SECTION 009113.10 - ADDENDUM NO. 1

- A. Project Name: Lewis County Fire Protection District No. 1 - Emergency Services Facility.
- B. Owner: Lewis County Fire Protection District No. 1.
 - 1. Owner's Representative: Brad Flexhaug, Fire Chief; Lewis County Fire Protection District No. 1; PO Box 100; Onalaska, WA 98570; (360) 520-3820; chieflcf1@gmail.com.
- C. Architect: Neil A Meyer, RA, AIA; meyArchitecture; (360) 701-4706; meyArchitecture@comcast.net.
- D. Architect Project Number: 17015.00.
- E. Date of Addendum: September 10, 2019.

FOUNDATION PLAN - BASE BID

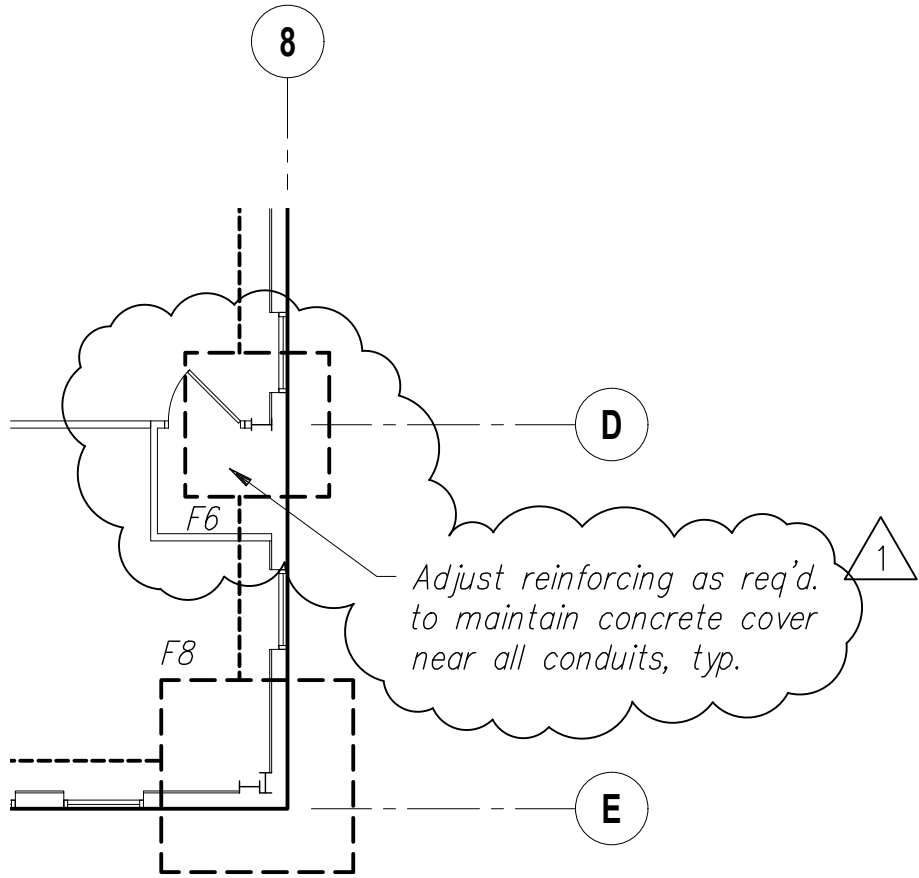
- a. Drawing Foundation Plan - Base Bid: Revised footing sizes at Grids 5-A and 5-E from an F79 to an F9 footing. Corrected detail callout near Grid 5-B to reference Detail 5/S5.0.

Rev.	Date	By	Description
1	09.10.19	ECM	Revised footing size and callout bubble

FOUNDATION PLAN - BASE BID

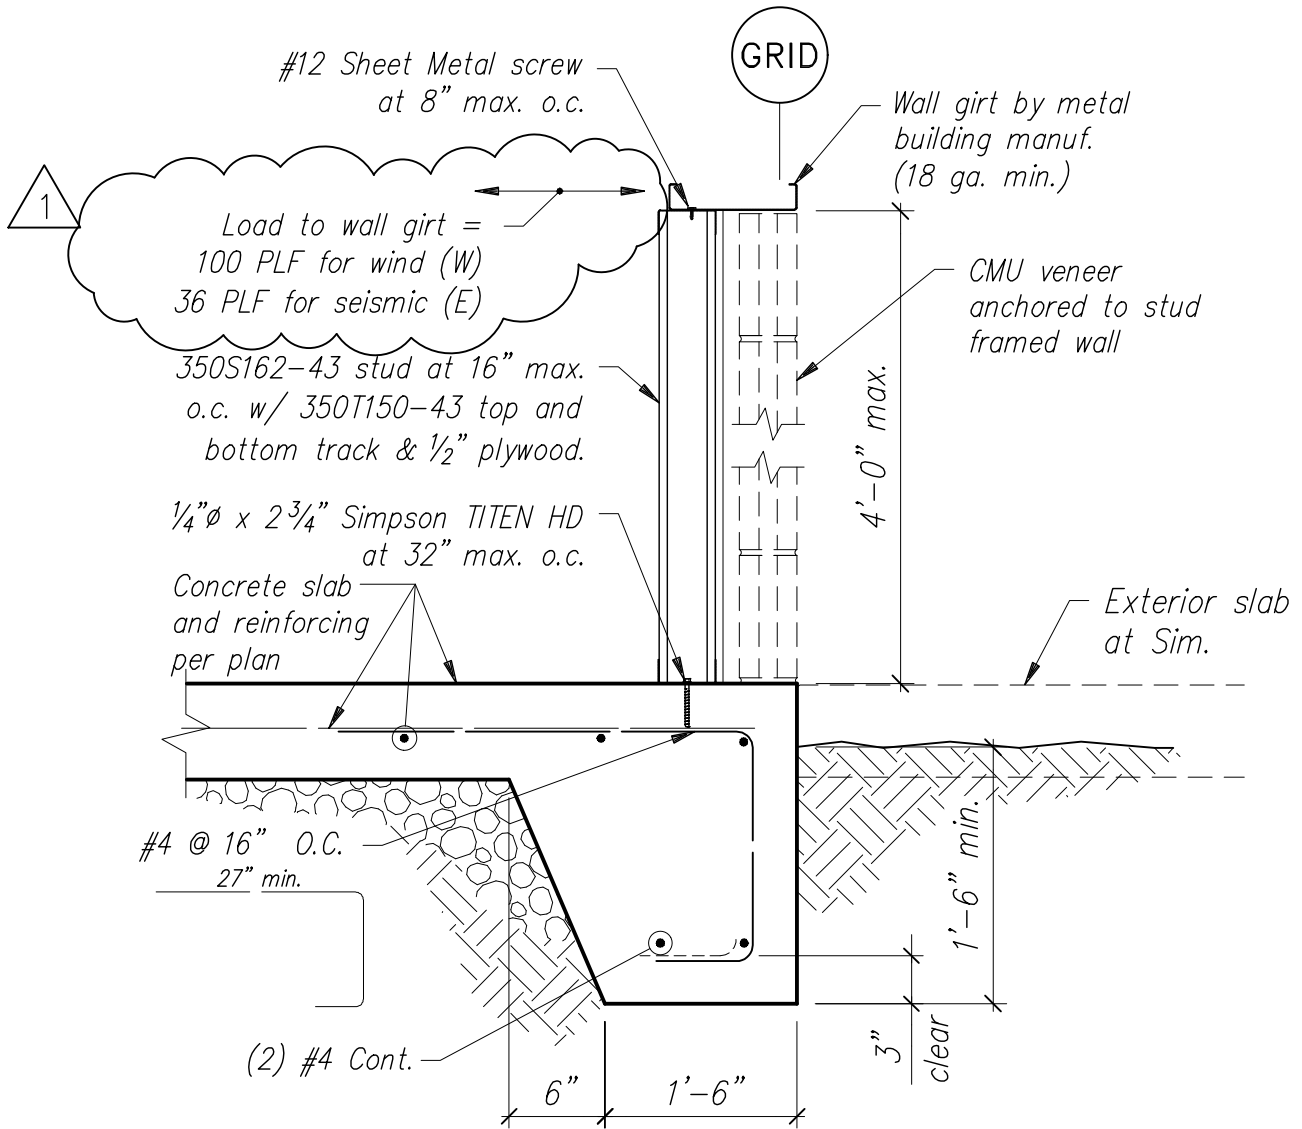
- 2. Structural Addendum Drawing SSK-2, revising Sheet S2.1 - Foundation & Loft Framing Plan.
 - a. Drawing Foundation Plan - Base Bid: Added note pertaining to conduit penetrations through footings.

Rev.	Date	By	Description
1	09.10.19	ECM	Added conduit clearance note.

DETAIL: CONCRETE EDGE W/ CMU WALL

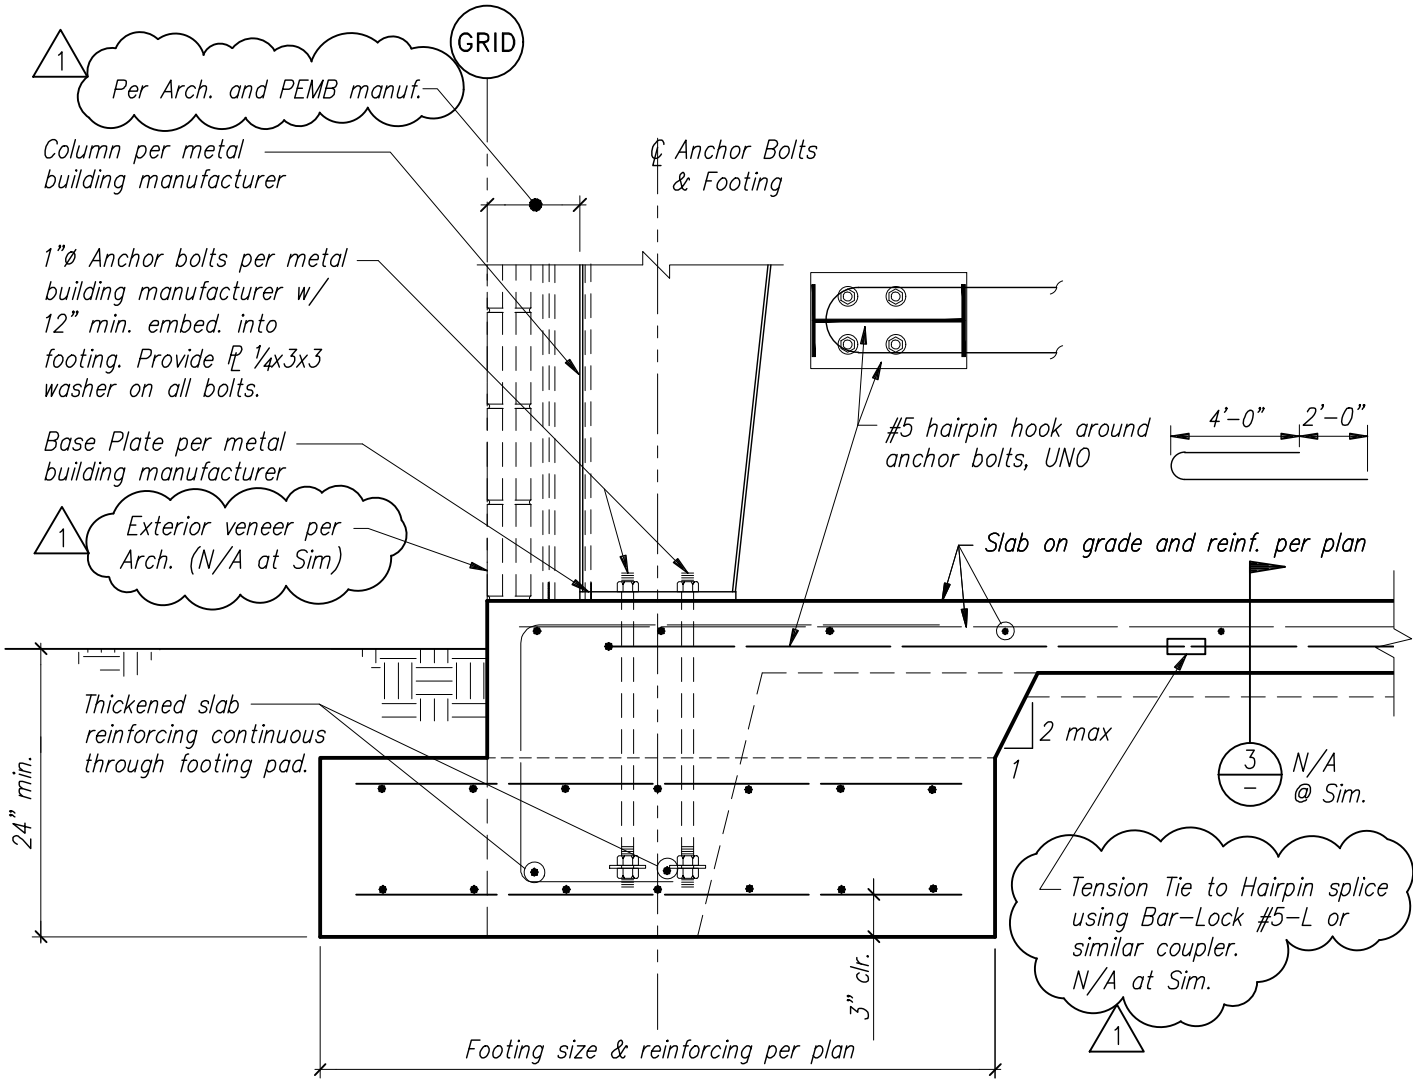
- 3. Structural Addendum Drawing SSK-3, revising Sheet S5.0 - Structural Details.
 - a. Drawing 2/S5.0 - Detail: Concrete Edge w/ CMU Wall: Revised wind and seismic loading from veneer into PEMB structure.

Rev.	Date	By	Description
1	09.10.19	ECM	Revised veneer loading to PEMB structure.

DETAIL: COLUMN FOOTING

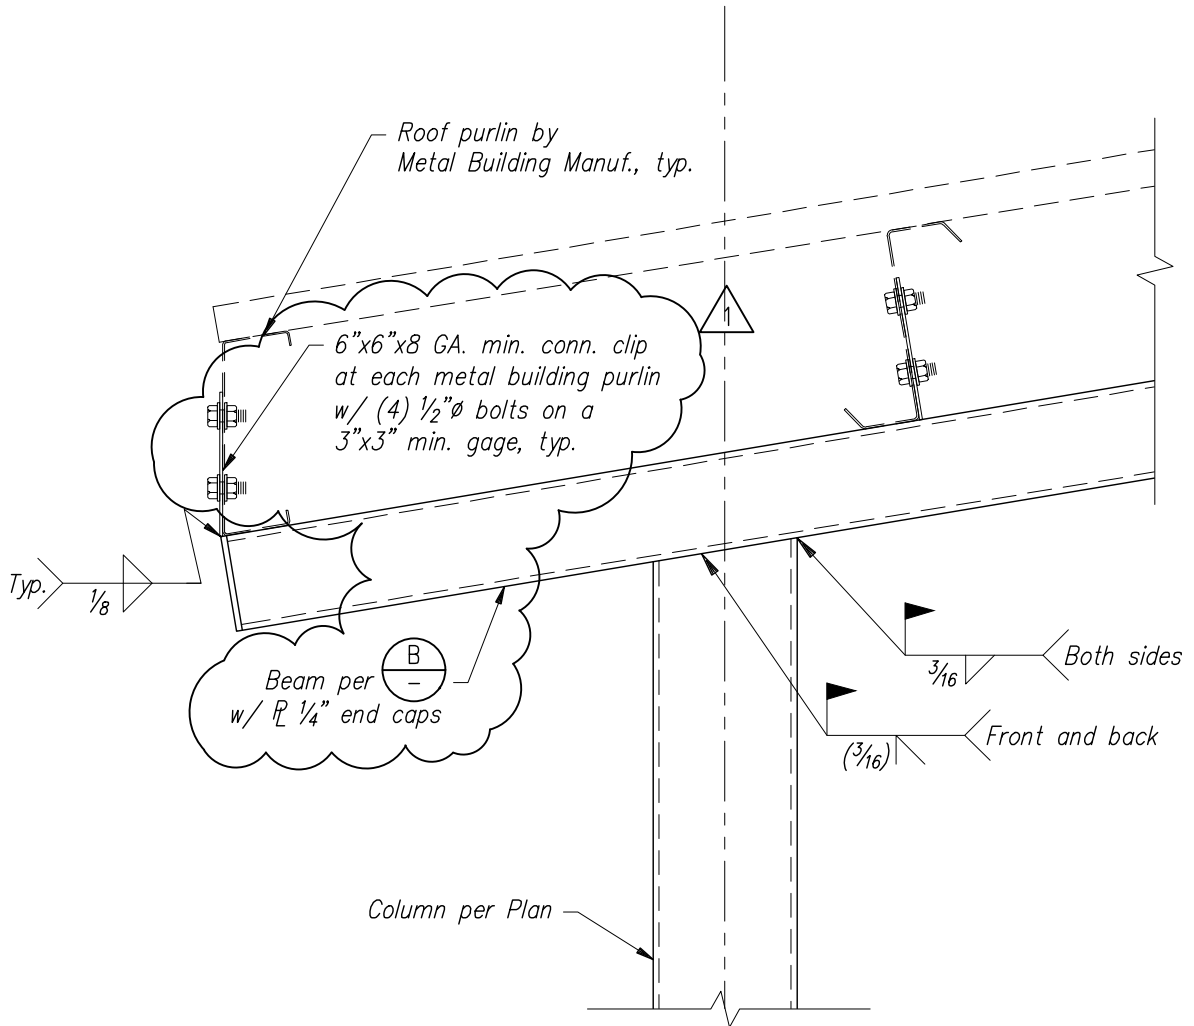
- 4. Structural Addendum Drawing SSK-4, revising Sheet S5.0 - Structural Details.
 - a. Drawing 5/S5.0 - Detail: Column Footing: Clarifications for several callouts.

Rev.	Date	By	Description
1	09.10.19	ECM	Revised callout notes for clarity.

2 FIRE ALARM FLOOR PLAN - ALTERNATE BID

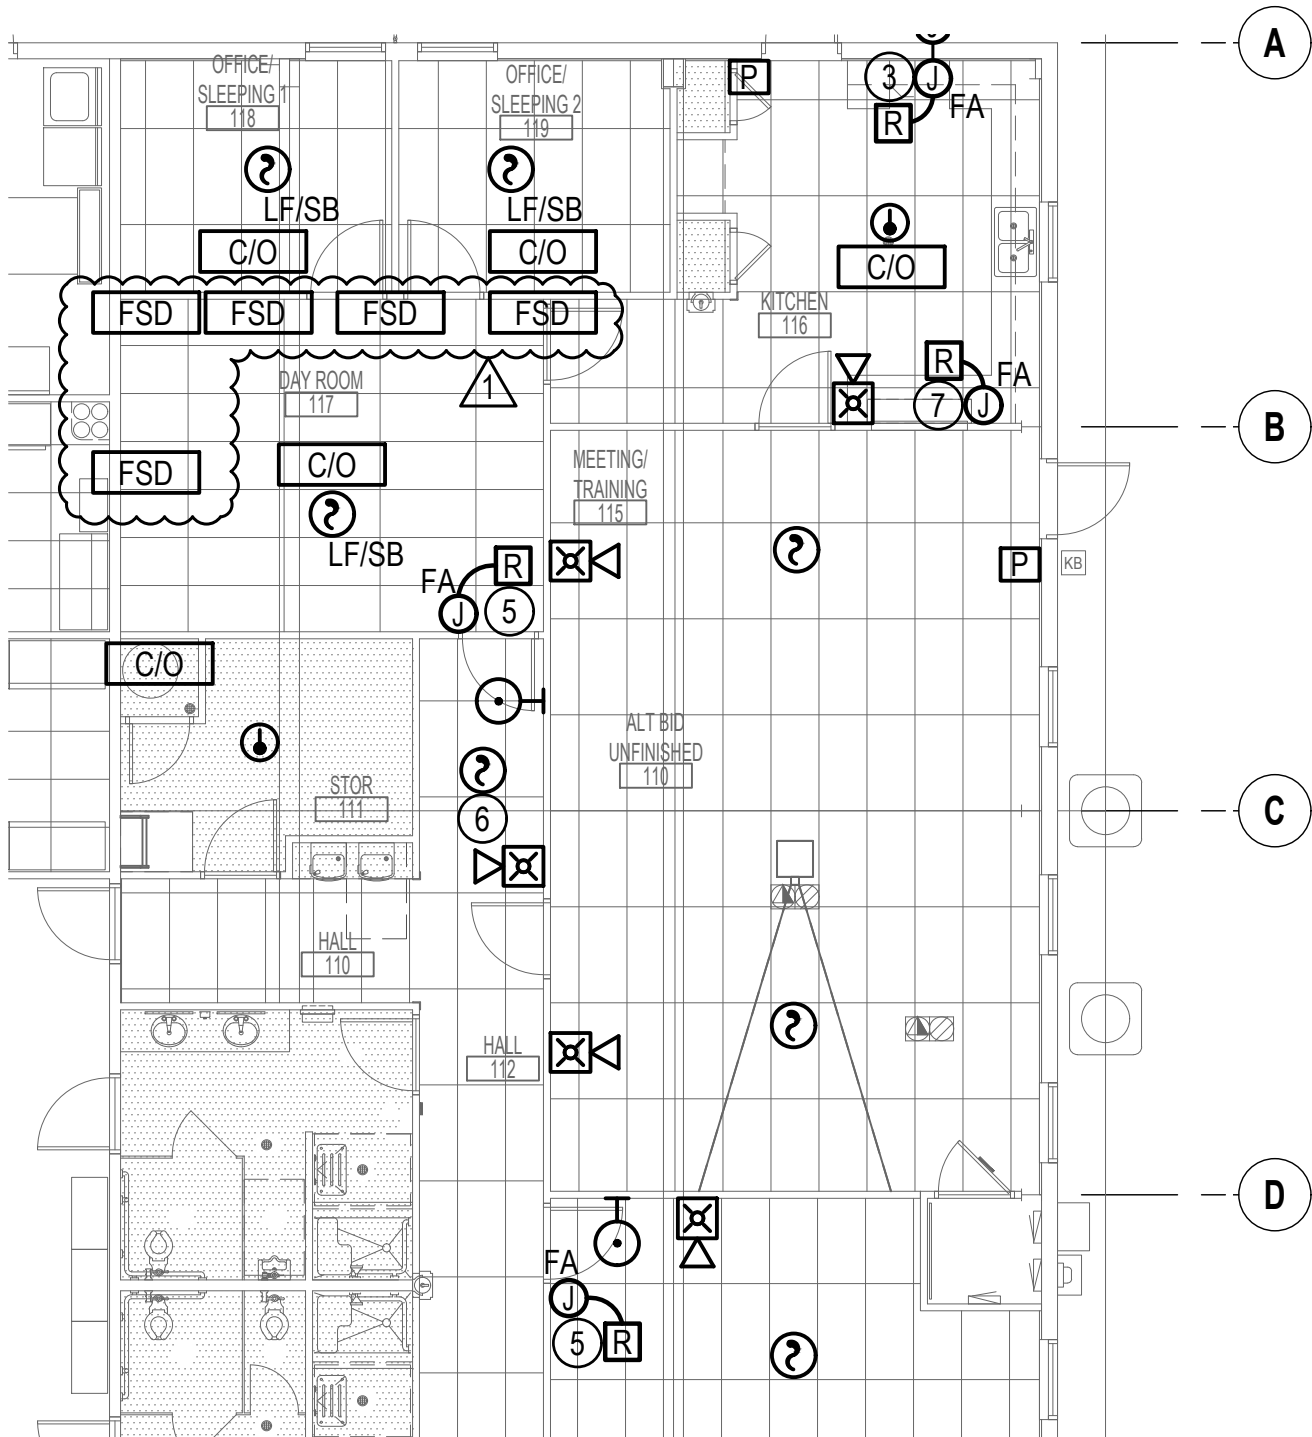
7. Fire Protection Addendum Drawing FASK-2.1, revising Sheet FA2.1 - Fire Alarm Floor Plan.
 - a. Drawing 2 - Fire Alarm Floor Plan - Alternate Bid: Add (5) Combination Fire Alarm Fire/Smoke Dampers. Connect dampers to fire alarm system.
